**Report of the Working Party on Passive Safety  
on its fifty-ninth session**

**Addendum 1**

## Draft 02 series of amendments to Regulation No. 129

**Figure 1**  
**Load cell positions**

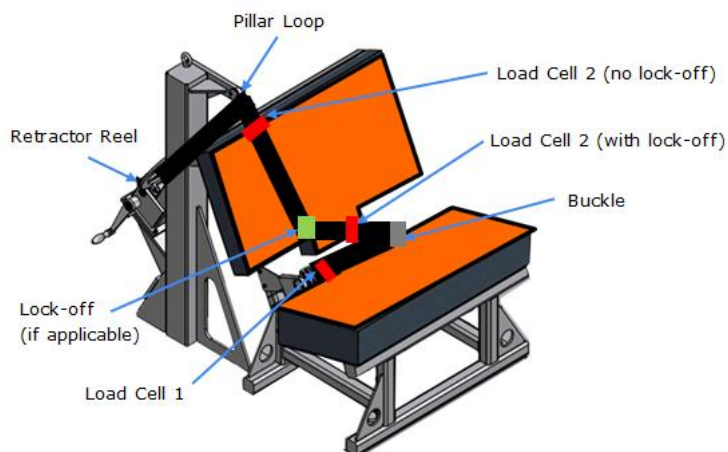
**7.1.3.5.2.2. Installation of a non-integral Enhanced Child Restraint Systems i-Size booster seat or specific to vehicle booster seat on the test bench.**

Fit load cell 1 to the outboard position as shown Figure 1. Install the Enhanced Child Restraint System in the correct position. If a lock-off device is fitted to the Enhanced Child Restraint System and acts upon

Adjust the lap portion of the reference belt to achieve a tension load of  $50 \text{ N} \pm 5 \text{ N}$  at load cell 1. Make a chalk mark on the webbing where it passes through the simulated buckle.

While maintaining the belt at this position, adjust the diagonal to achieve a tension of  $50 \text{ N} \pm 5 \text{ N}$  at load cell 2 by either locking the webbing at the Enhanced Child Restraint System webbing locker or by pulling the belt between the belt clamping mechanism and the standard retractor. If the tension in load cell 2 is achieved by pulling the belt between the clamping mechanism and the retractor, the clamping mechanism shall now be locked.

## "Annex 2

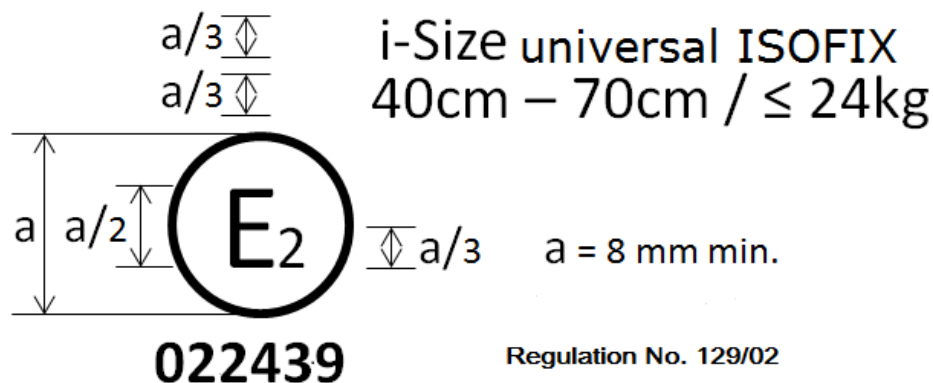
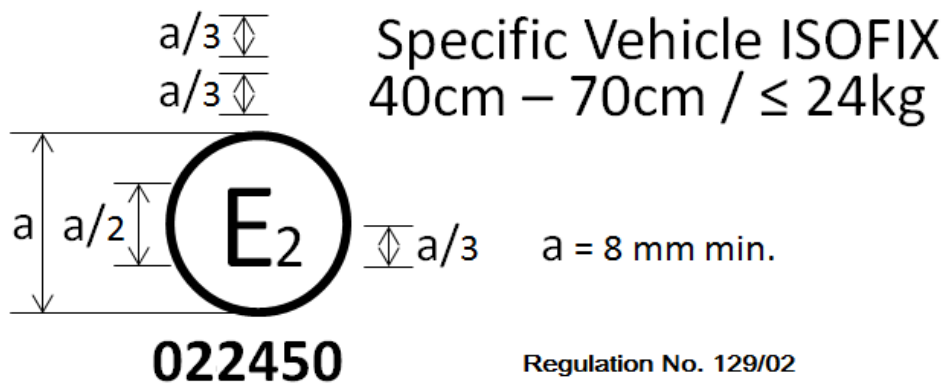
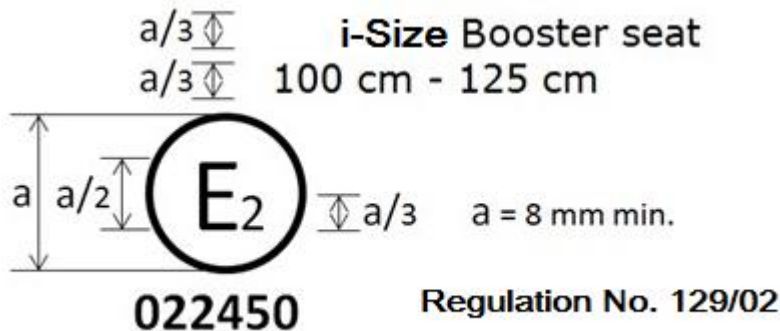
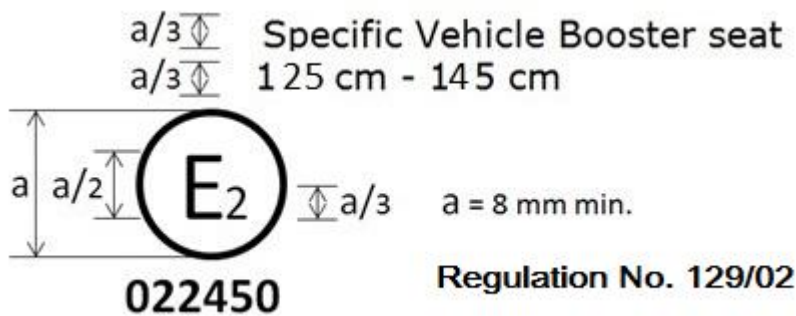
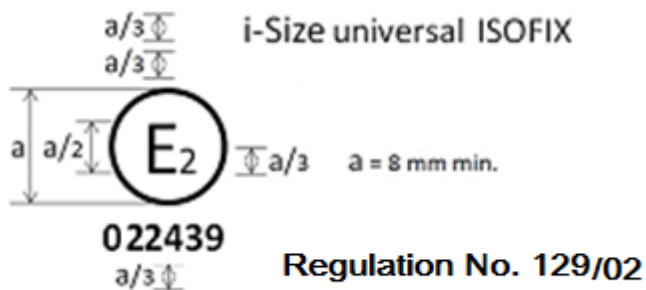
Annex 2, amend to read:

The Enhanced Child Restraint System bearing the above approval mark can be fitted in any i-Size booster seating position and used for the 100 cm - 125 cm size range; it is approved in France (E 2) under the number 022450. The approval number indicates that the approval was granted in accordance with the requirements of the Regulation concerning the approval of Enhanced Child Restraint Systems used on-board of motor vehicles as amended by the 02 series of amendments. In addition, the name of the regulation is to be identified on the approval mark followed by the series of amendment according to which the approval has been granted.

In case the ECRS is equipped with a module, the size range is not on the approval mark but on the module mark.

## "Annex 6 - Appendix 2

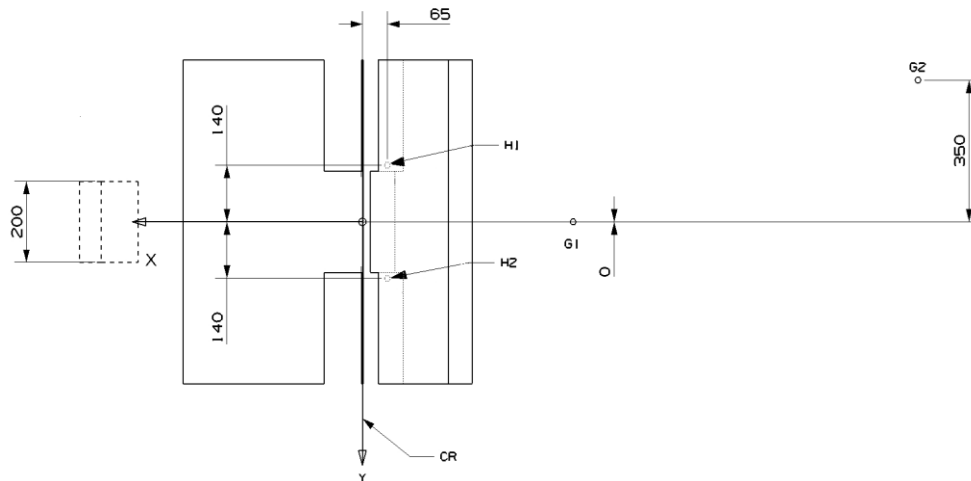
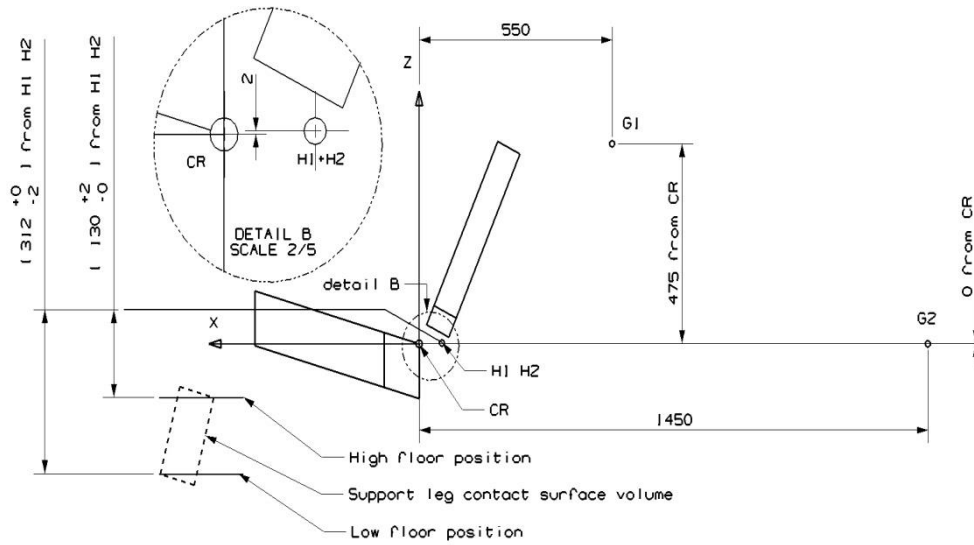
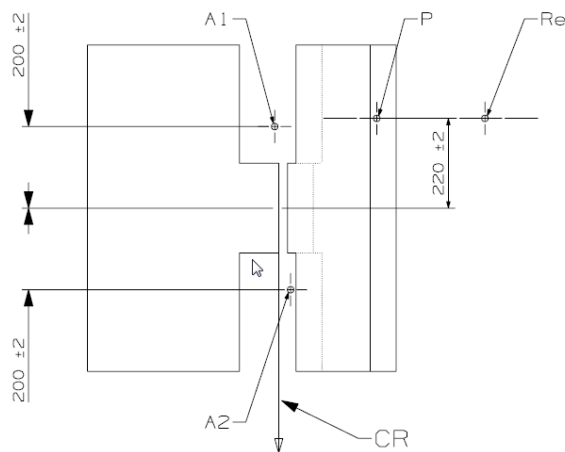
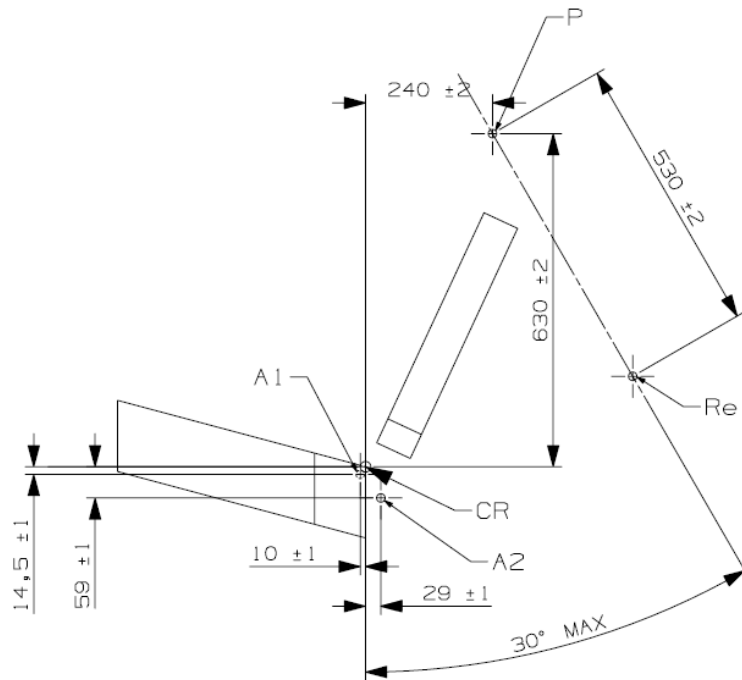
*Annex 6, Appendix 2, amend to read:*

1. The anchorages shall be positioned as shown in the figure below.
2. Enhanced Child Restraint Systems in the i-Size universal, specific and restricted categories shall use the following anchorage points: H<sub>1</sub> and H<sub>2</sub>.

3. For testing of Enhanced Child Restraint Systems with top tether, the anchorage G<sub>1</sub> or G<sub>2</sub> shall be used.
4. In the case of Enhanced Child Restraint Systems utilising a support-leg, the Technical Service shall select the anchorages to be used according to paragraph 3. above and with the support-leg adjusted as specified in paragraph 7.1.3.6.3. of this Regulation.

## "Annex 18

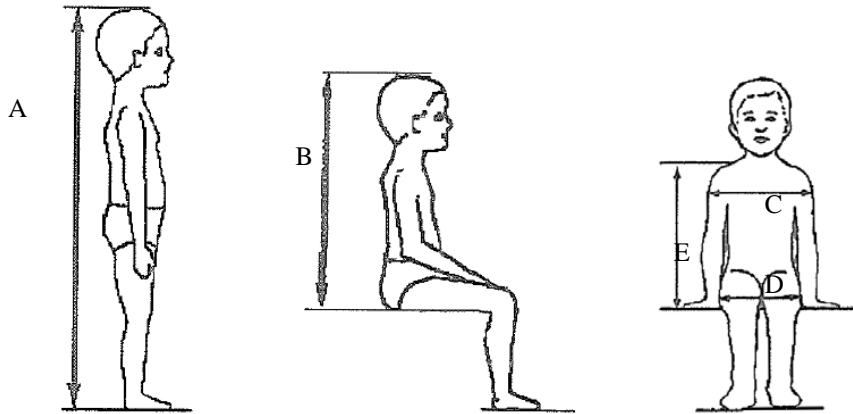
Annex 18, amend to read:

<i>Stature cm</i>	<i>Minimum Sitting height cm</i>	<i>Minimum Shoulder breadth cm</i>	<i>Minimum Hip breadth cm</i>	<i>Minimum Shoulder height cm</i>	<i>Maximum Shoulder height cm</i>
<i>A</i>	<i>B</i>	<i>C</i>	<i>D</i>	<i>E1</i>	<i>E2</i>
	<i>95%ile</i>	<i>95%ile</i>	<i>95%ile</i>	<i>5%ile</i>	<i>95%ile</i>
≤40				≤27.4	
45	39.0	12.1	14.2	27.4	29.0
50	40.5	14.1	14.8	27.6	29.2
55	42.0	16.1	15.4	27.8	29.4
60	43.5	18.1	16.0	28.0	29.6
65	45.0	20.1	17.2	28.2	29.8
70	47.1	22.1	18.4	28.3	30.0
75	49.2	24.1	19.6	28.4	31.3
80	51.3	26.1	20.8	29.2	32.6
85	53.4	26.9	22.0	30.0	33.9
90	55.5	27.7	22.5	30.8	35.2
95	57.6	28.5	23.0	31.6	36.5
100	59.7	29.3	23.5	32.4	37.8
105	61.8	30.1	24.9	33.2	39.1
110	63.9	30.9	26.3	34.0	40.4
115	66.0	32.1	27.7	35.5	41.7
120	68.1	33.3	29.1	37.0	43.0
125	70.2	<b>33.3</b>	<b>29.1</b>	38.5	44.3

<i>Stature cm</i>	<i>Minimum Sitting height cm</i>	<i>Minimum Shoulder breadth cm</i>	<i>Minimum Hip breadth cm</i>	<i>Minimum Shoulder height cm</i>	<i>Maximum Shoulder height cm</i>
<i>A</i>	<i>B</i>	<i>C</i>	<i>D</i>	<i>E1</i>	<i>E2</i>
	<i>95%ile</i>	<i>95%ile</i>	<i>95%ile</i>	<i>5%ile</i>	<i>95%ile</i>
130	72.3	<b>33.3</b>	<b>29.1</b>	40.0	46.1
135	74.4	<b>33.3</b>	<b>29.1</b>	41.5	47.9
140	76.5	<b>34.2</b>	<b>29.6</b>	43.0	49.7
145	78.6	<b>35.3</b>	<b>30.8</b>	44.5	51.5
150	81.1	<b>36.4</b>	<b>32.0</b>	46.3	53.3

Figure 1  
Standard seat belt configurations

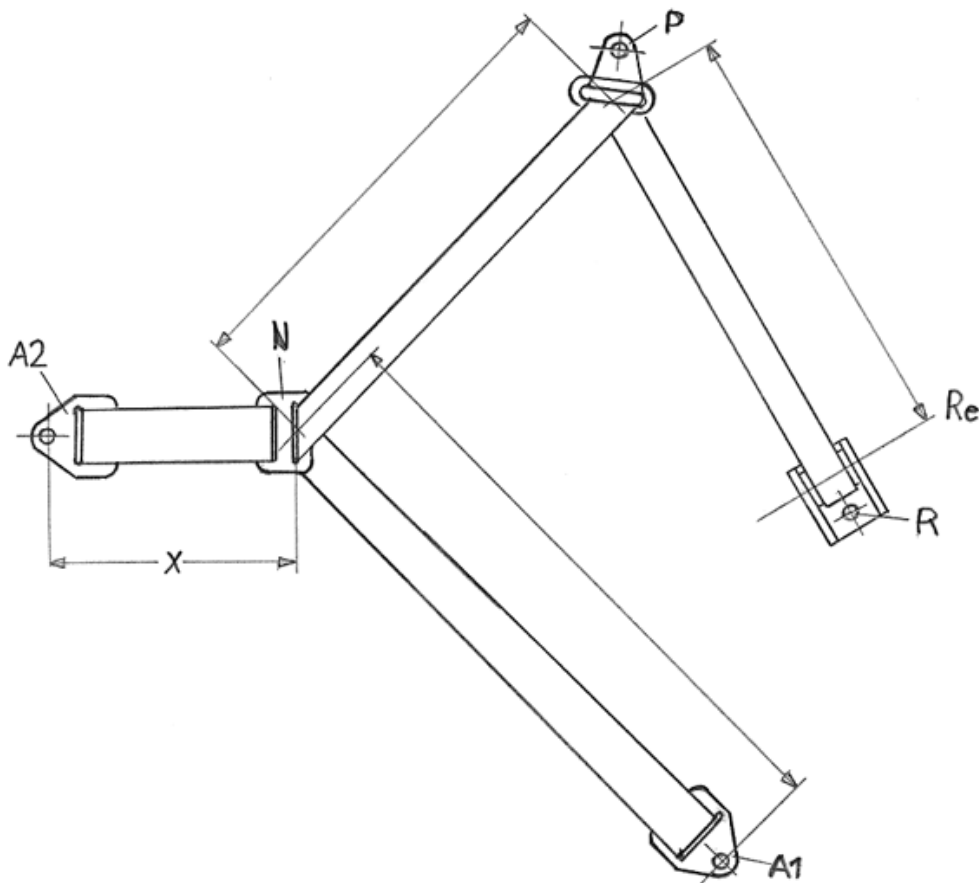
Insert new Annex 23, to read:

1. The safety-belt for the dynamic test and for the maximum length requirements shall be made according to the configuration shown in Figure 1. These are a three-point retracting belt system.

The value of X in Figure 1 below is  $200 \pm 5$  mm. The effective strap length between A1 and the centre line of the retractor spool Re (when the webbing is fully extracted including the minimum length of 150 mm for testing of Enhanced Child Restraint System shall be  $[2,820] \pm 5$  mm when measured in a straight line without load and on a horizontal surface. This length may be increased for the testing of restricted categories; for all categories with the Enhanced Child Restraint System installed, there shall be a minimum of 150 mm of strap length on the retractor spool.
